City Council Memorandum

SUBJECT: PLANNING CASE P03-1451 (Appeal by Jim Guthrie. Friends of Riverside's <u>Hills, Robert and Susan Burton</u>): Proposed Tract Map 31930 by Gabel, Cook and Becklund, on behalf of Jim Guthrie, to subdivide approximately 86.31 vacant acres into 29 residential and 5 open space lots, located southerly of terminus of Cresthaven Drive and northerly of Alessandro Arroyo in the RC - Residential Conservation and O - Official Zones.

PLANNING CASE P03-1548 (Appeal by Jim Guthrie): Proposed revised planned residential development (PD-001-912) by Gabel, Cook and Becklund, on behalf of Jim Guthrie, consisting of 29 single family residences with private and common open space on approximately 86.31 vacant acres, located southerly of terminus of Cresthaven Drive and northerly of the Alessandro Arroyo in the RC - Residential Conservation and O - Official Zones.

PLANNING CASE P04-0260 (Appeal by Robert and Susan Burton) : Proposal by Gabel, Cook and Becklund, on behalf of Jim Guthrie, to rezone approximately 7 acres from the O – Official Zone to the RC – Residential Conservation Zone located along the southerly portion of a 29-unit planned residential development, si

TOPOGRAPHIC MAP TM 31930

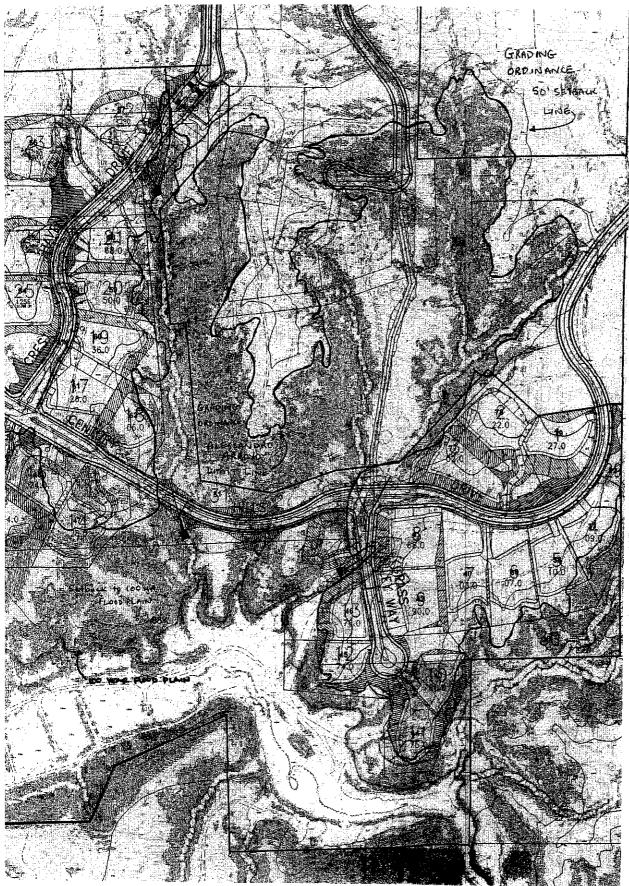
Neignbors' properties who have objected to lot 53

Location of tee area on lot 60 and putting green on lot 53
